RE: Harnett County Anderson Creek C&DLF (Permit No. 43-03)
Phases I & II Extension - Revised Final Cover Grading Plan

ANDERSON CREEK C&D LANDFILL PHASES I & II

REVISED FINAL COVER GRADING PLAN

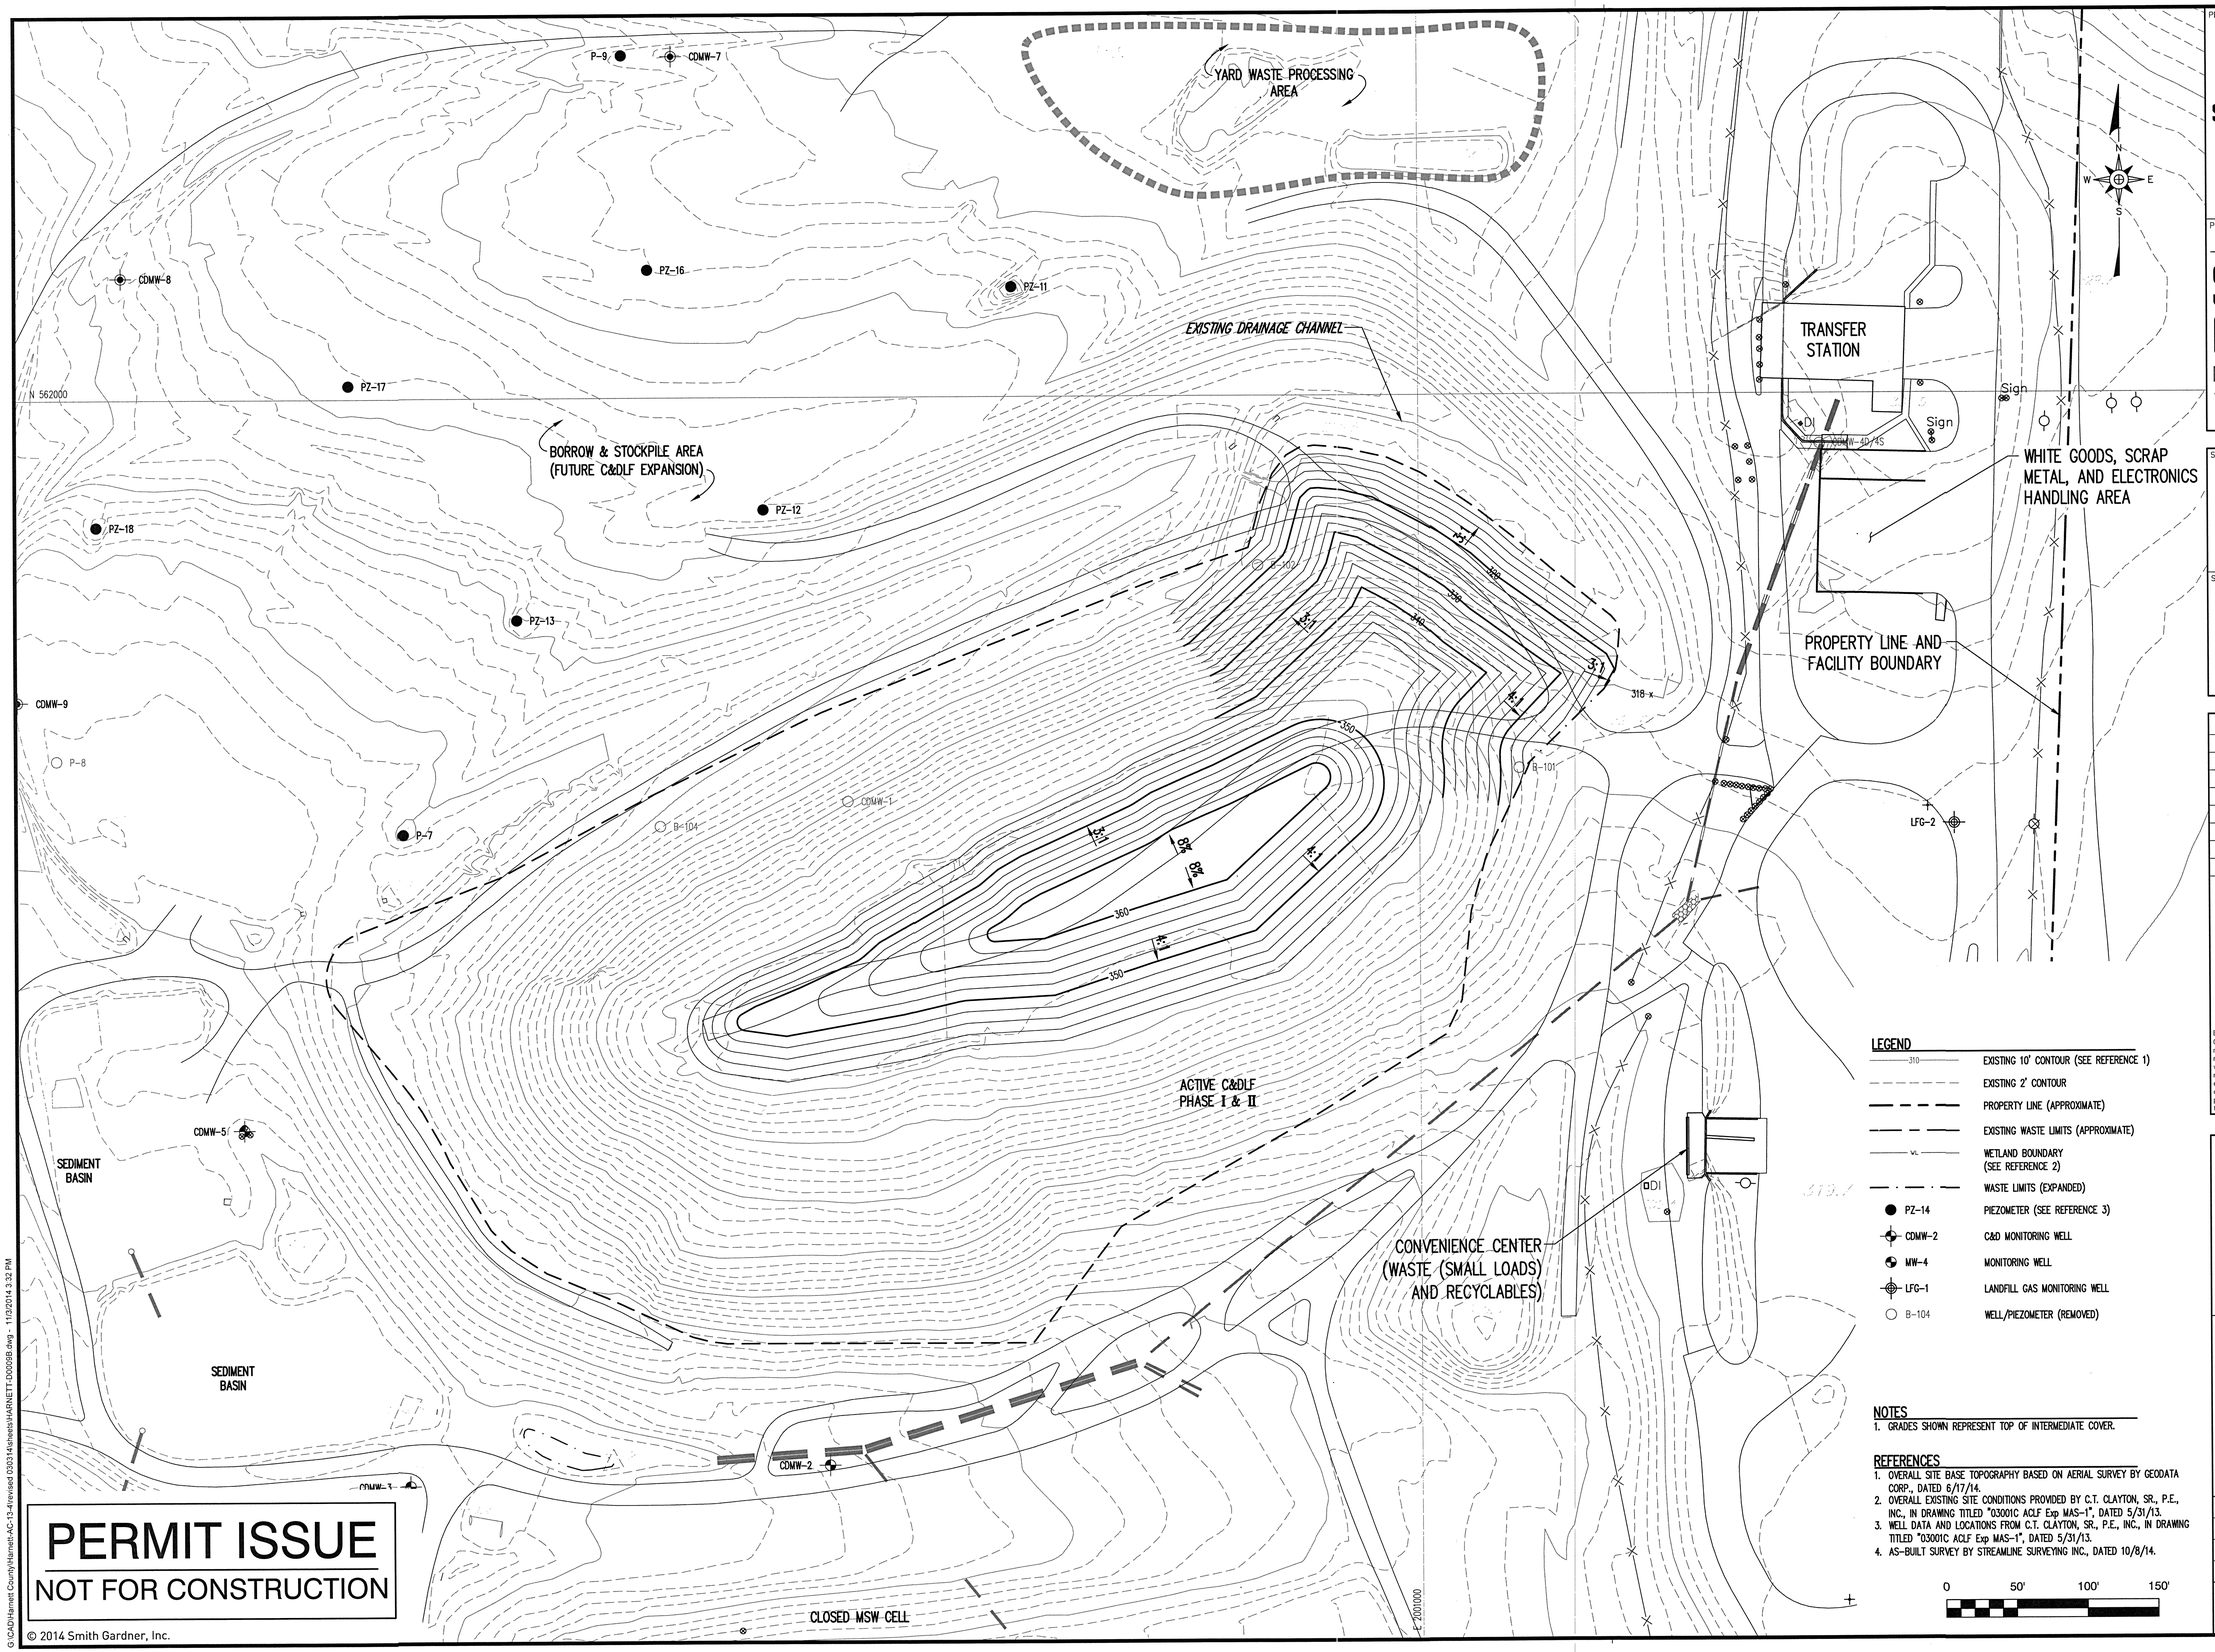
Per your request and on behalf of Harnett County, Smith Gardner, Inc. (S+G) would like to provide the **attached** revised final cover grading plan. This plan revises the final grading plan shown in the approved permit drawings to reflect the as-built berm location for the Phases I & II Extension which was documented in the recently submitted CQA report.

Attachments: Revised Final Cover Grading Plan
Cut/Fill Isopach - Revised Grades to 2013 Topo.
Cut/Fill Isopach - Permit Grades to 2013 Topo.

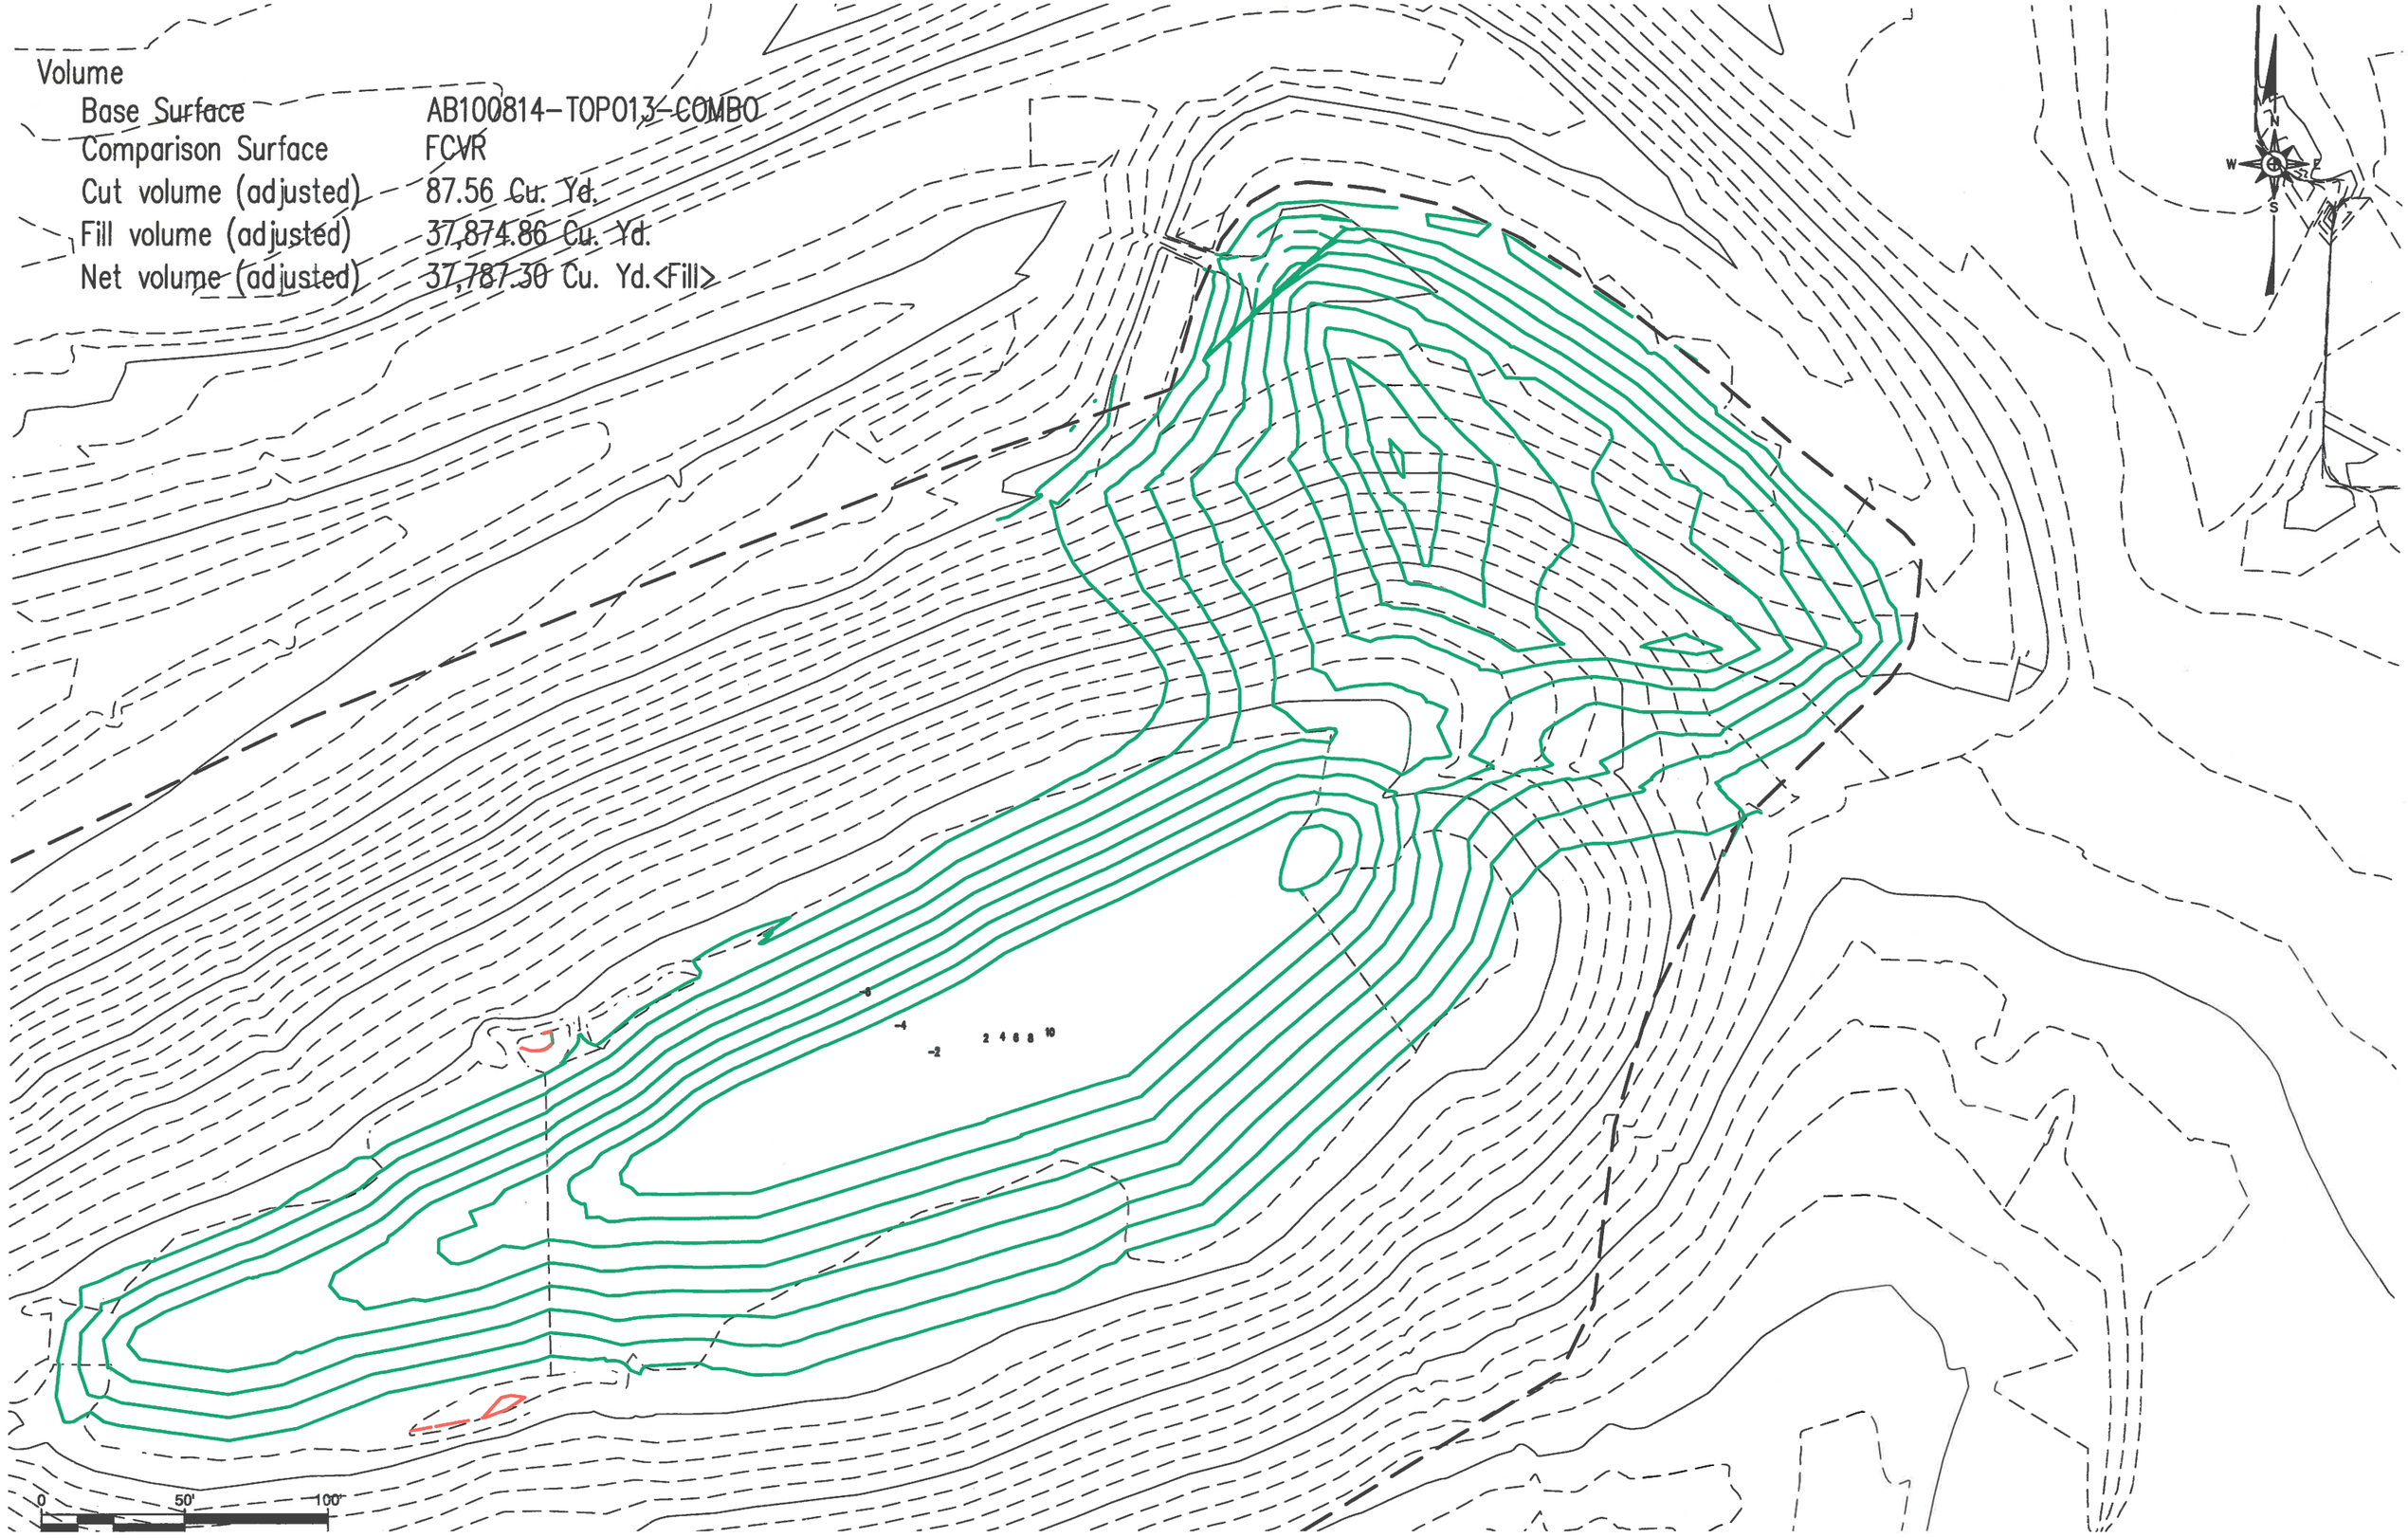
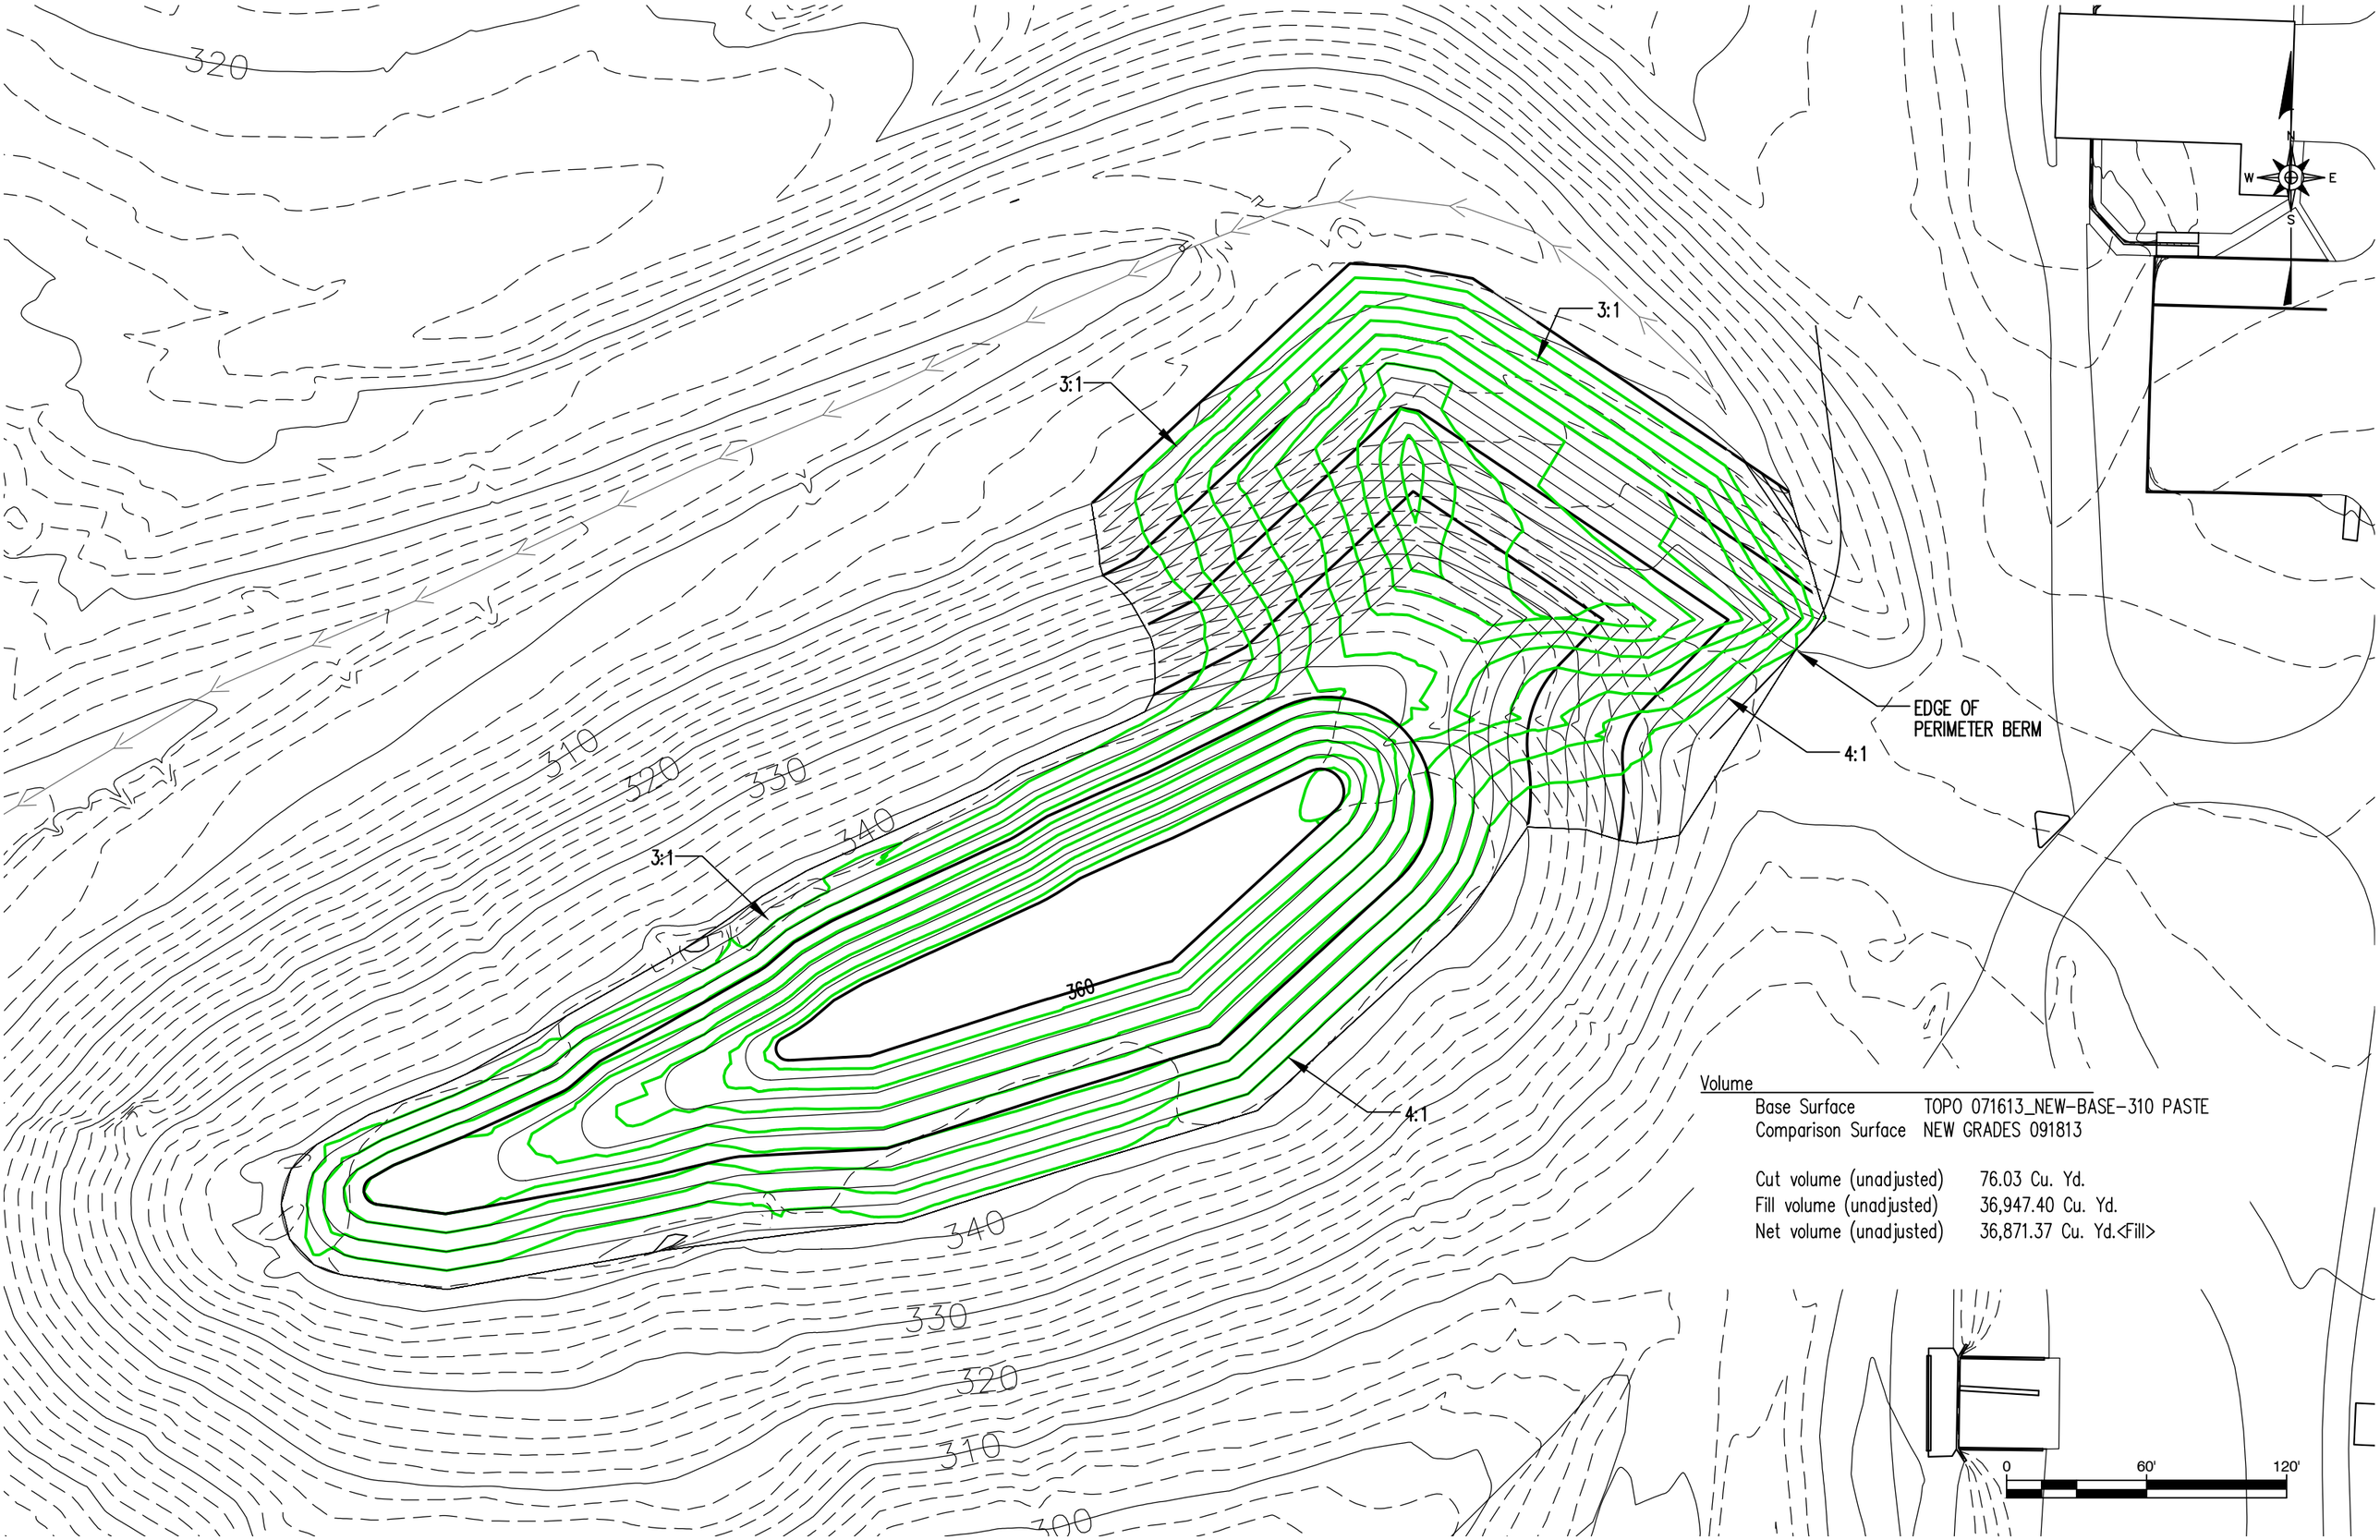
In order to demonstrate that the revised grading plan provides essentially the same capacity as that previously approved, the net volume between the as-built grades for the Phases I & II Extension and 2013 topography was determined. This volume (37,787 CY from 2013 topography to top of intermediate cover) was compared with the volume for the previously permitted grading plan (36,871 CY from 2013 topography to top of intermediate cover) (see **attached** cut/fill isopachs). Given that the net volume figures are within approximately 2.5% of each other, the capacity of the revised grading plan is essentially the same capacity as that previously approved.
